LEGISLATIVE COUNCIL

LC1528. Hon Ben Dawkins to the Minister for Environment.

**GREATER BUNBURY REGION SCHEME AMENDMENT – 0020/57 -
PROPOSAL TO ESTABLISH THE DALYELLUP WASTEWATER TREATMENT PLANT ODOUR
BUFFER AREA AND TO INSERT SPECIAL CONTROL AREA NO 4 FOR WASTEWATER
TREATMENT PLANT ODOUR BUFFERS IN GREATER BUNBURY REGION SCHEME TEXT**

INTRA-DEPARTMENTAL REQUEST FOR INFORMATION/ ADVICE UNDER SECTION 48C(1) OF THE *ENVIRONMENTAL PROTECTION ACT 1986*

Figure 1

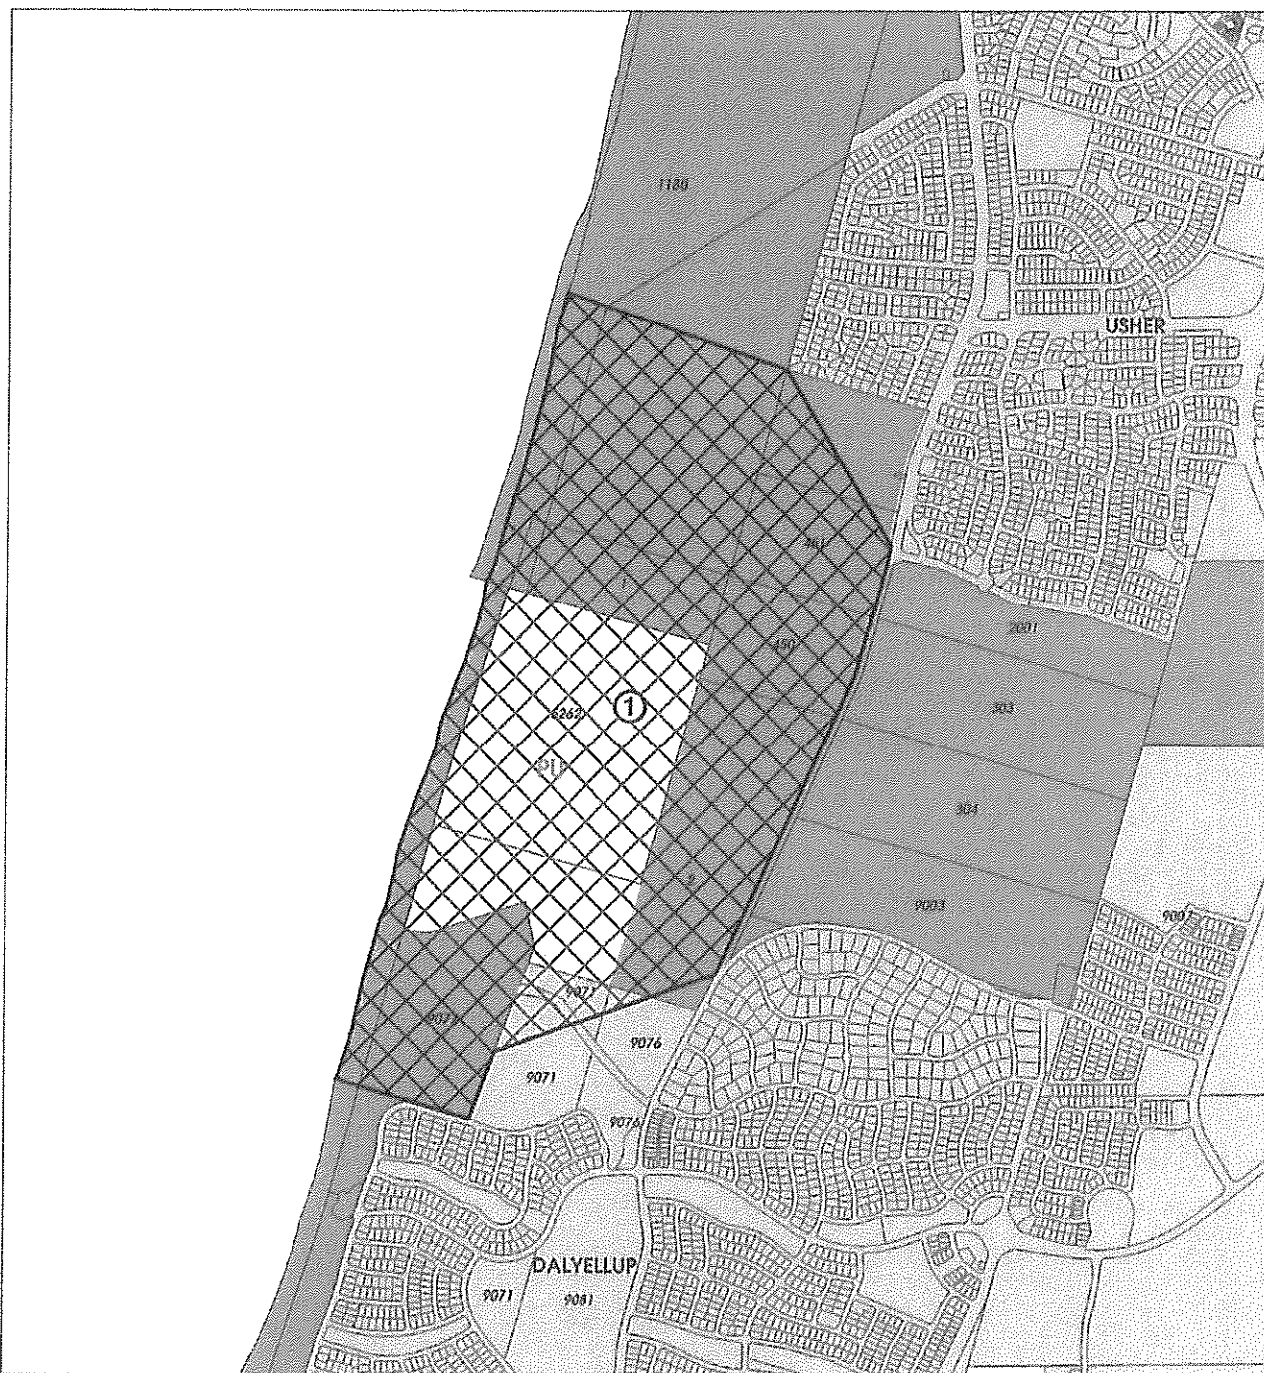
The Water Corporation's letter to the Department of Planning dated 22 August 2011, states that they are confident in their 2007 odour modeling assessment, and the technology of the 2009 upgraded plant, being of a standard that confirms suitability of the buffer boundary as indicated on the scheme amendment's "Proposed amendment to the Greater Bunbury Region Scheme - Wastewater Treatment Plant Odour Buffer – Special Control Area (SCA No 4)" dated 12 April 2011 (Figure 1).

Given the Water Corporation's stated expertise and confidence in the adequacy of their 2007 odour modeling assessment data, and in the 2009 plant upgrade, DEC would expect that if any unreasonable emissions are emitted from the subject site in the future, that Water Corporation would be agreeable to undertake odour remediation to the satisfaction of DEC.

DEC requests a letter from Water Corporation which confirms the commitment of Water Corporation to undertake odour remediation to the satisfaction of DEC if any unreasonable odours are emitted from the premises. DEC also expects to find a clear statement about the actions to be implemented, if such odour emissions occur, in the Odour Management Plan (OMP) that Water Corporation would provide to DEC. In addition, any DEC approved OMP is likely to be included in the site's EP Act license.

Therefore, if Water Corporation provides an assurance they will undertake additional odour management, to the satisfaction of DEC, if odour complaints associated with the wastewater treatment plant occur following the introduction of the SCA No4 buffer area, then DEC has no additional comments to make regarding the proposed scheme amendment.
